STAFF REPORT: JULY 10, 2024 MEETING
APPLICATION NUMBER: HDC2024-00329
ADDRESS: 1450 SEYBURN
HISTORIC DISTRICT: WEST VILLAGE
APPLICANT: VOYTEK MARDULA
PROPERTY OWNER: VADELLA LLC
DATE OF PROVISIONALLY COMPLETE APPLICATION: JUNE 18, 2024
DATE OF STAFF SITE VISIT: JUNE 21, 2024

SCOPE: ALTER PORCH (WORK COMPLETED WITHOUT APPROVAL), PAINT TRIM AND PORCH POSTS, RETAIN FRONT DOOR SURROUND

Photos from 2013 HDC application.

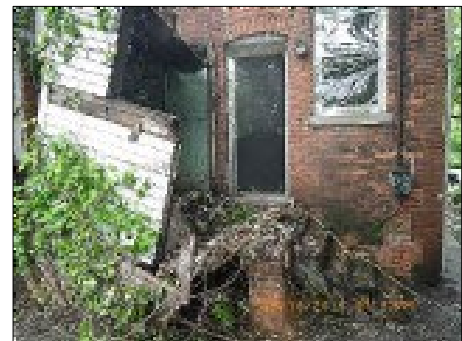
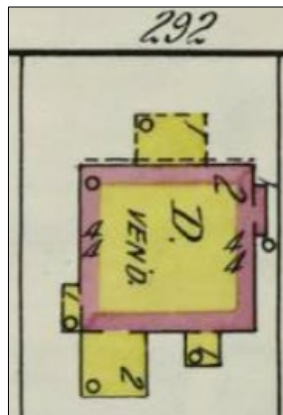
The circa 2013 photos below offer a visual confirmation of the materiality of the rear two-story extension and single story porch at the north end of the wall (which was in a severe state of disrepair).

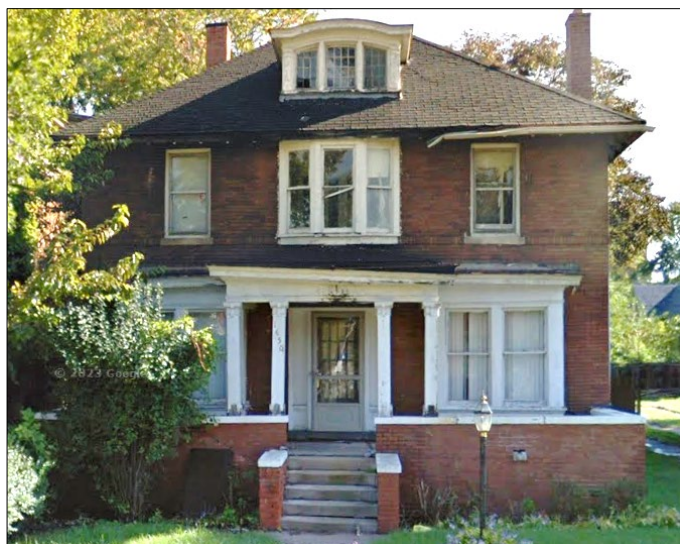
July 2009, Google streetview. The porch roof is beginning to sag, but otherwise the façade is intact. This photo offers a good view of the 16-light wood front door and wood side panels.

It appears the historic front door was replaced during the time between these two images, but the side panels remain. The new door appears to be a solid panel unit.
